ENGINEERING ORDER

2. DWG TITLE	3. DWG CAGE CODE	4. DWG NO.
PRESSURE OPERATED RAM AIR CONTROL VALVE	86090	60593-2

This EO adds Item Unique Identification (IUID) requirements to the drawing

PN 60593-2 (REF)

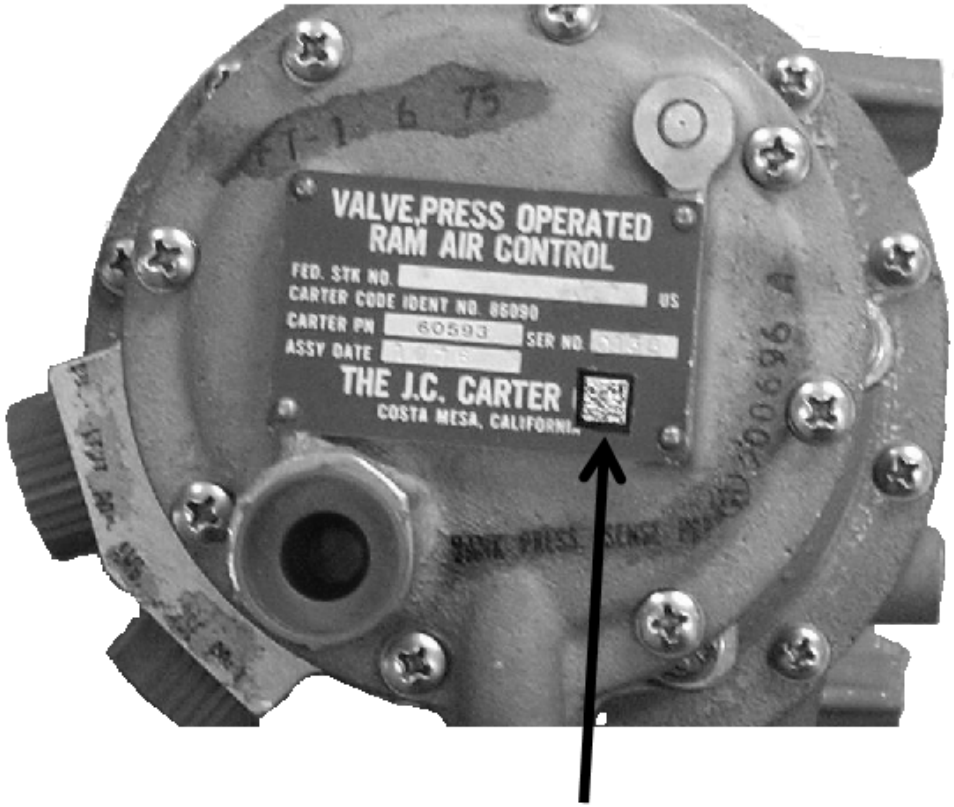
- F-15 Aircraft Pressure Operated Ram Air Control Valve (PN 60593-2) shall be marked with a Unique Item Identifier (UII). (REF: MIL-STD-130)

- If no UII symbol is present, fabricate new identification plate (200945069-501) to add to the existing identification plate/label (PN 200698).

- New UID identification plate will be located in the lower right corner on existing ID plate/label. See sketch/photo on page 2, AF form 3926.

- After attaching IUID plate to end item, apply a thin overcoat to IUID plate ensuring the plate edges are sealed, using 1A20, 1A33, or equivalent Polyurethane Conformal Coating, per manufacturer's instructions. REF: MIL-I-46058C.

IDENTIFICATION PLATE
PN 200945069-501
